MATERIALS LICENSE

Amendment No. 45

September 25, 1996

re: US NRC Region III letter from CFGill to CWSmith
dated August 28, 1996 and NRC Control # 301423.

Appendix 1

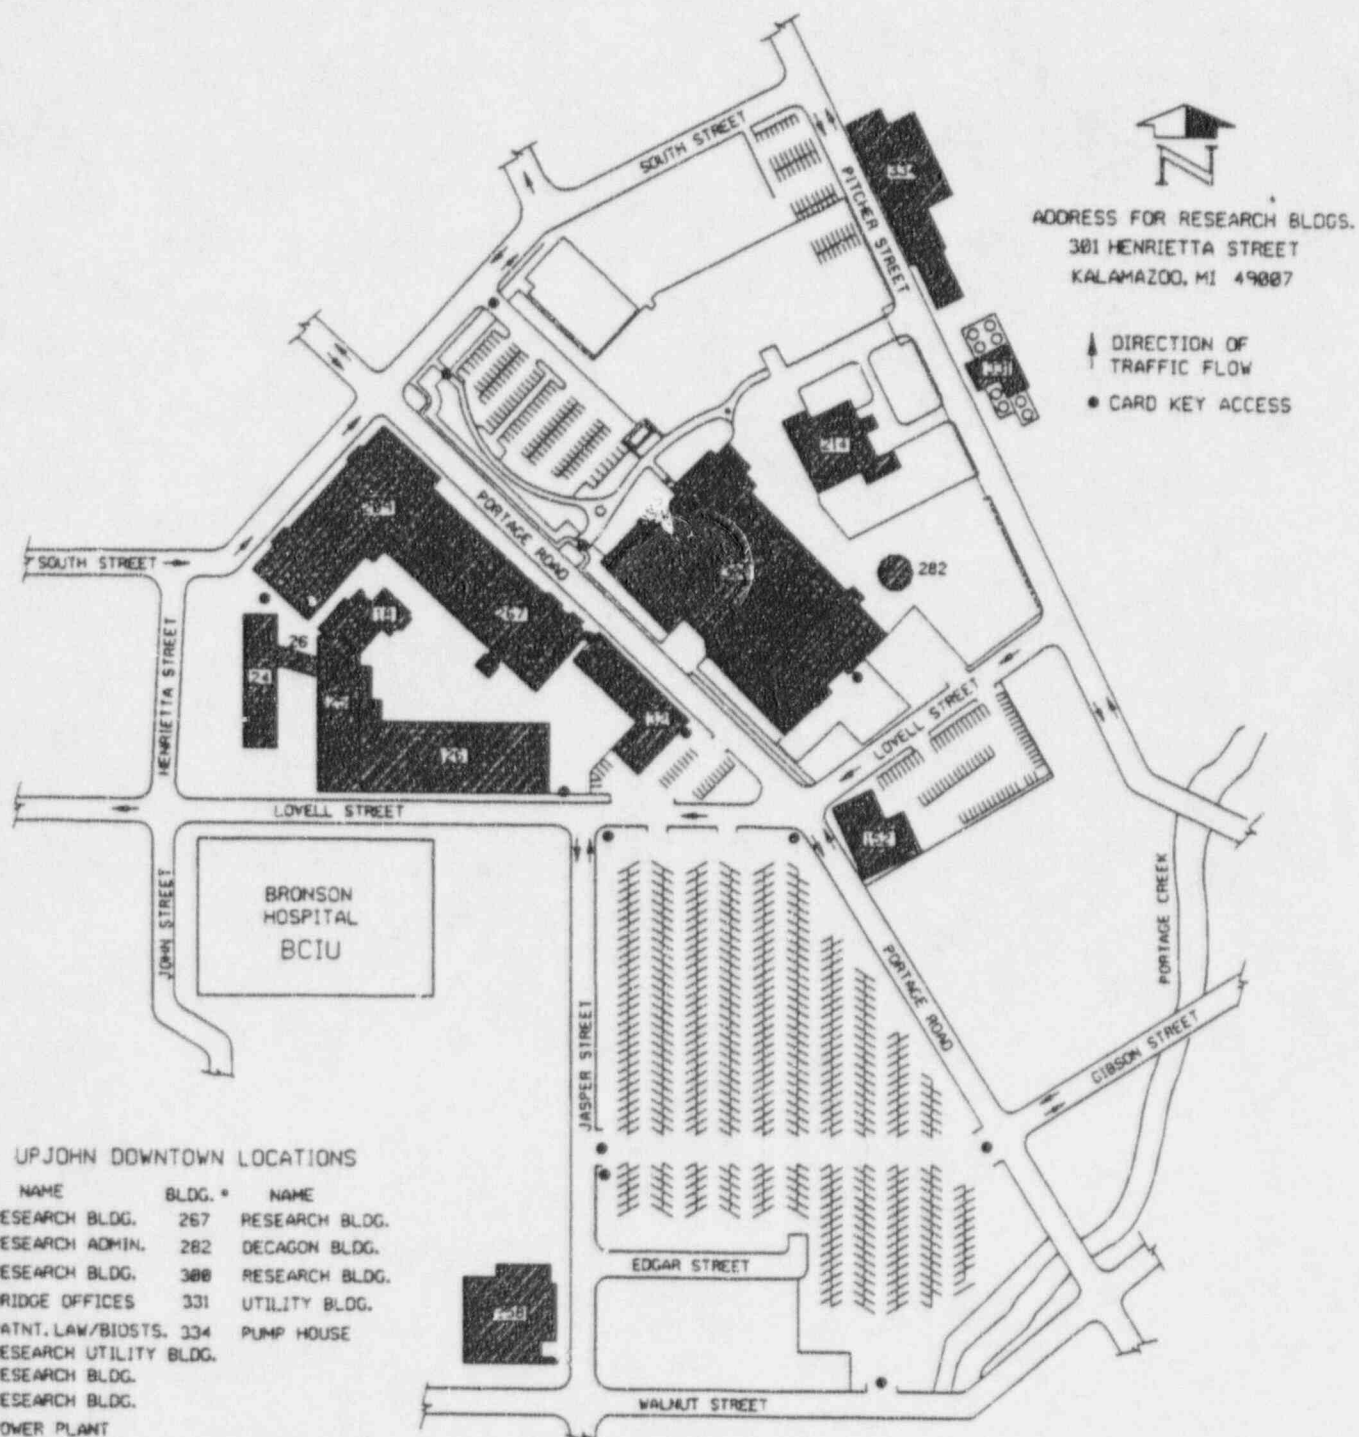
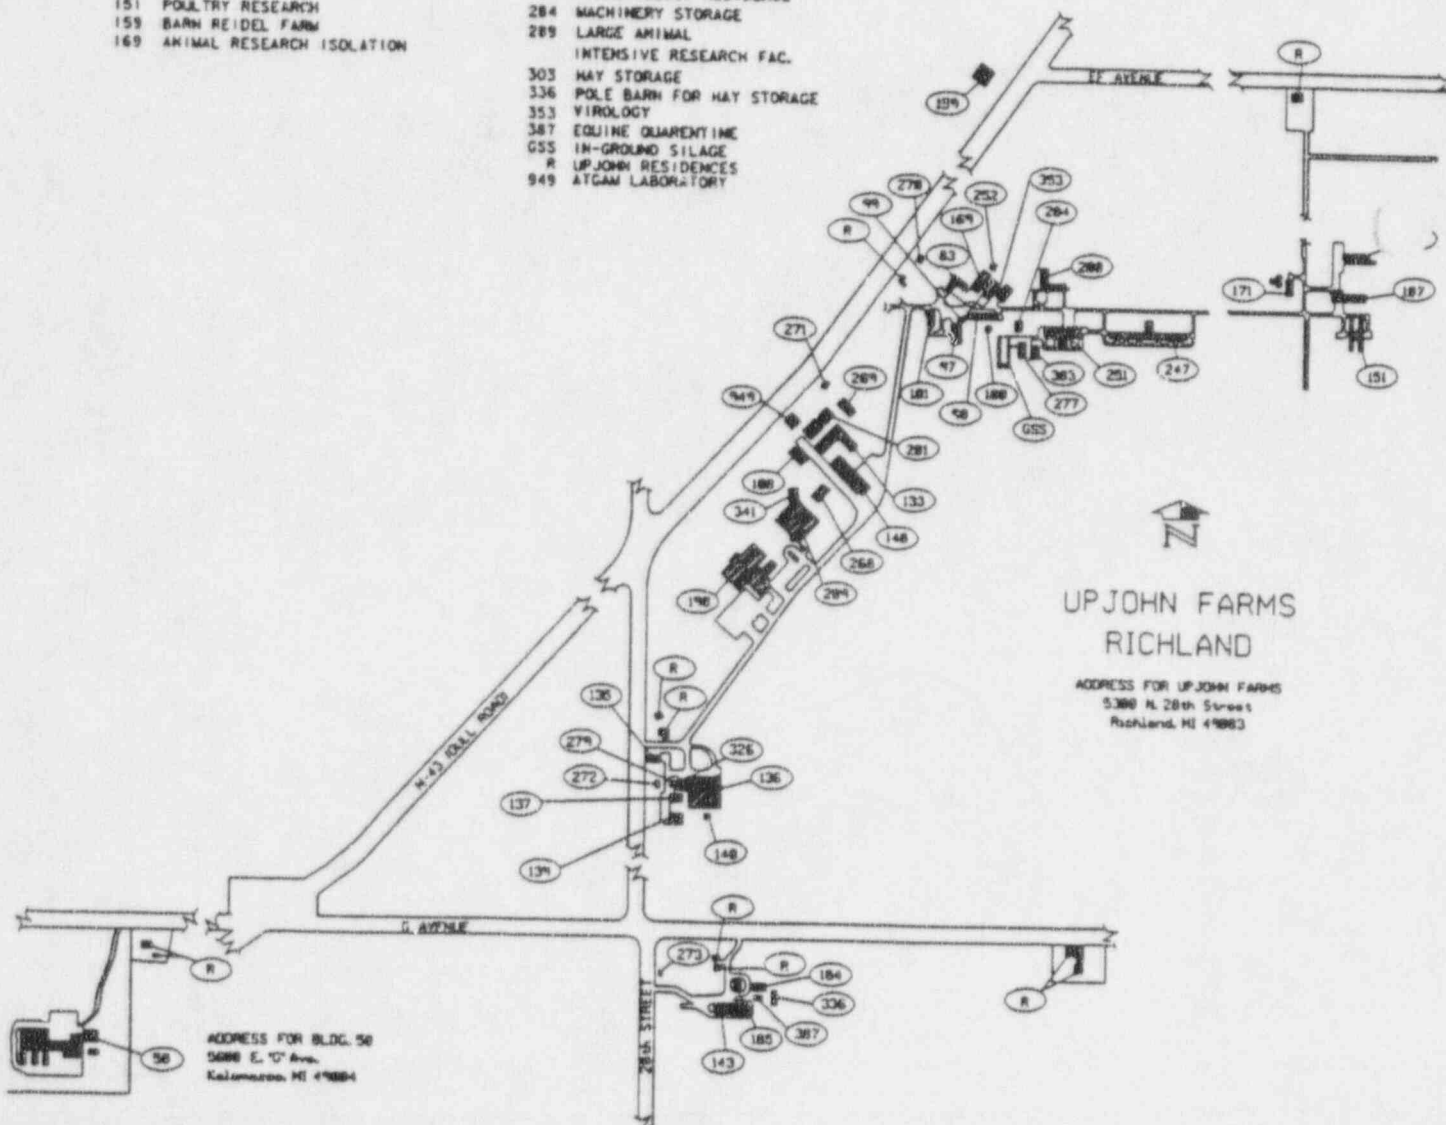
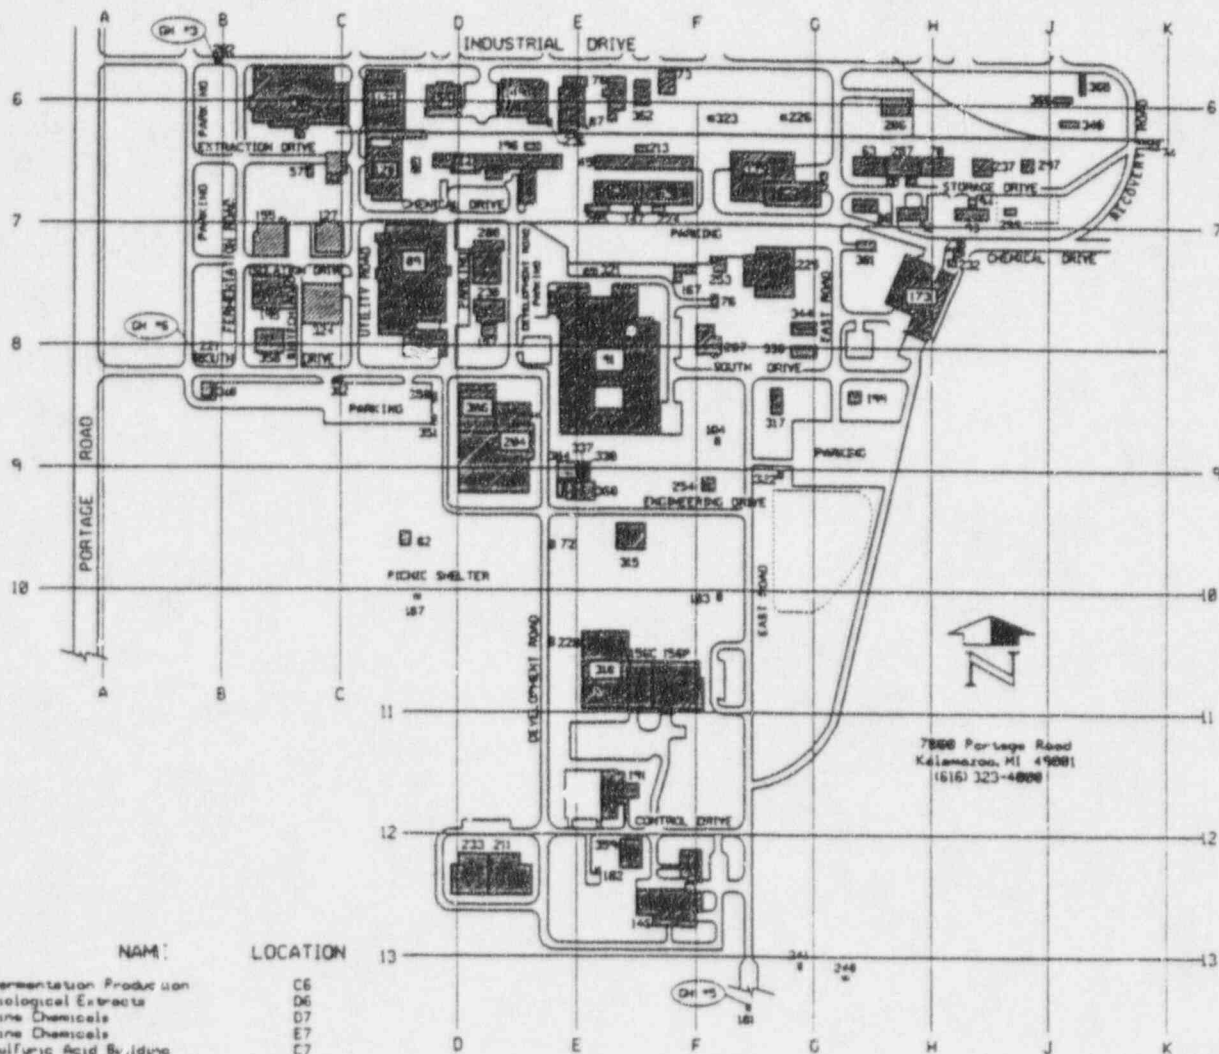
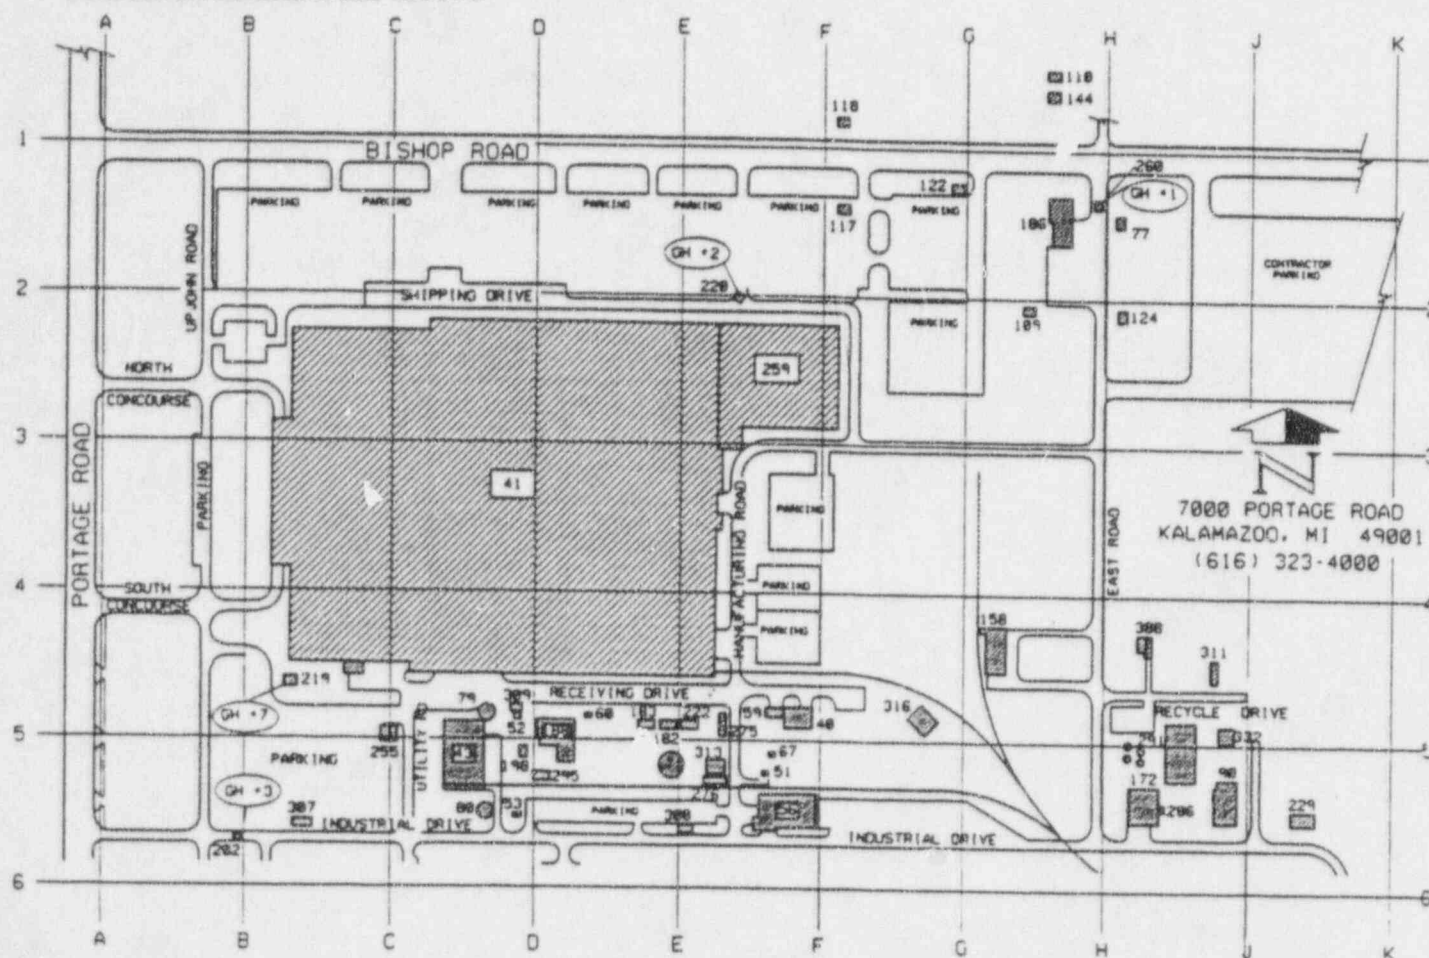
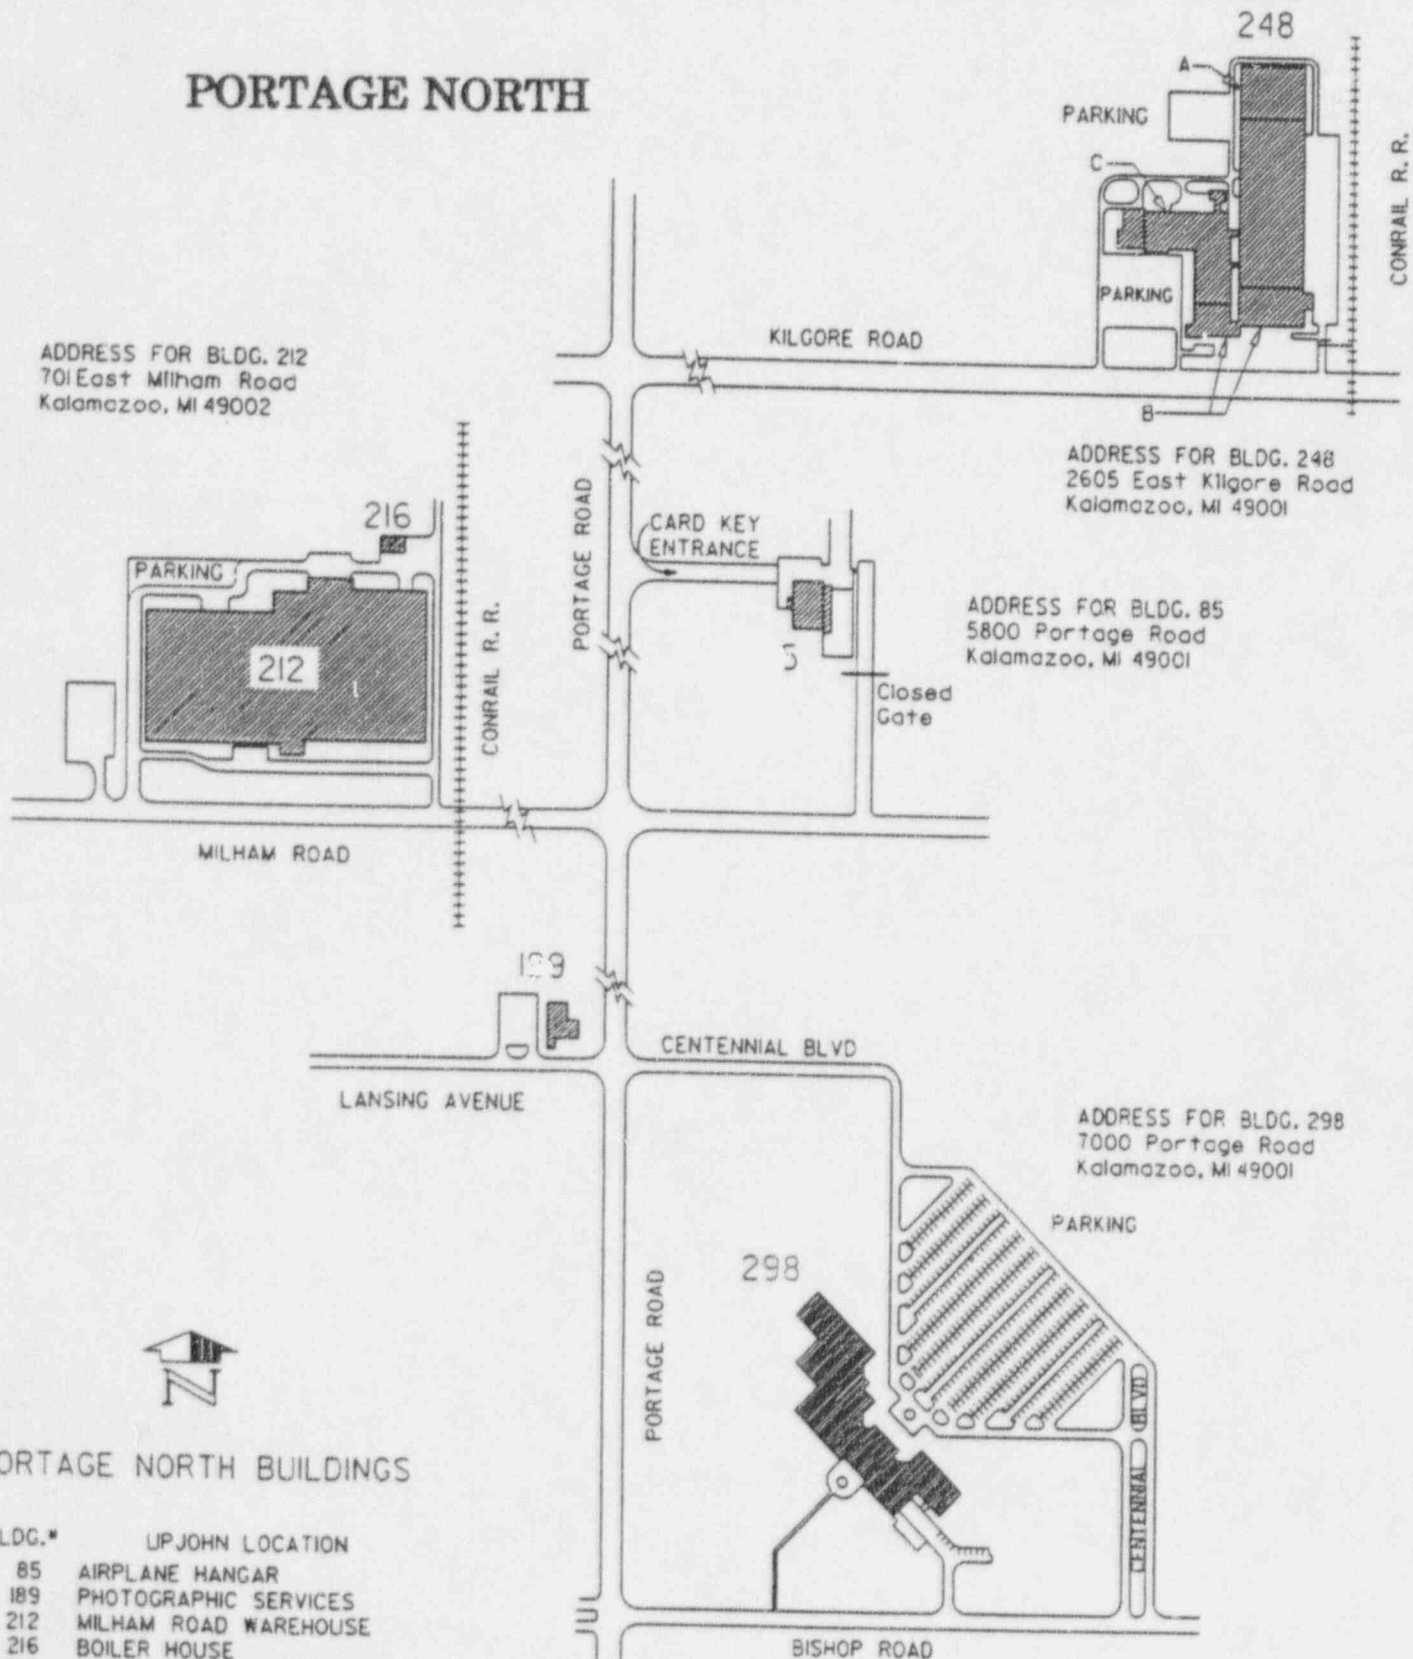
You stated in Attachment 1 that the current facilities layouts for the locations where licensed material will be used or possessed was in Attachment 3B. However, this document was not in your submittal.

Attachment 3B, "NRC License Requirements" section, was submitted as part of a license amendment dated April 7, 1995. Although the information has not changed since that submittal, a copy of 3B has been included as Appendix 1 to this letter.
